Service Bulletin

December 7, 1989

Subject: Changes to Eaton® Light Duty Hydrostatic Transaxles - Series 750, 850, 770, and 780.

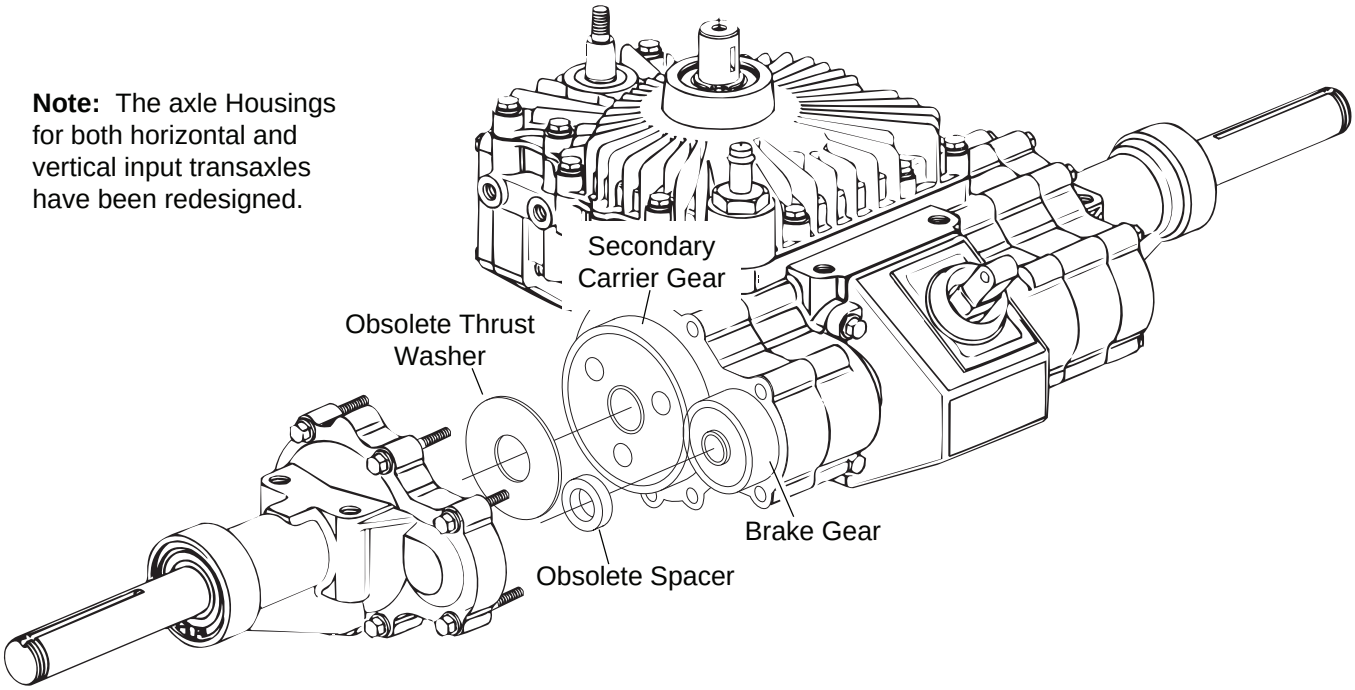
The axle housings on all Light Duty Hydrostatic Transaxles, Series 750, 850, 770, and 780, have been redesigned. The redesigned axle housings no longer require the thrust washer or spacer, see drawing below.

Note: The axle Housings for both horizontal and vertical input transaxles have been redesigned.

The thrust washers, spacers, and old style axle housings are no longer available. If any of these parts need to be replaced you must Install the new style axle housing.

This change became effective July 1, 1989. Units manufactured after the change will have a date code of G01J or higher. The parts lists for these transaxles (form numbers 6-412, 6-413, 6-416, and 6-417) have been revised and are dated November, 1989.
